Errata

NFPA 70[®]

2014 Edition

Errata No.: 70-14-1

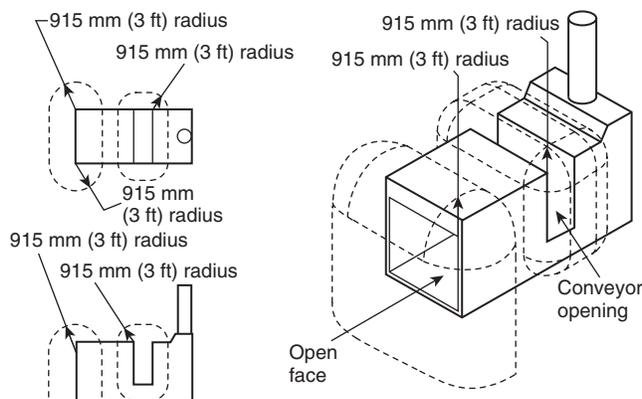
11. Replace Figure 516.3(D)(2) with the following:
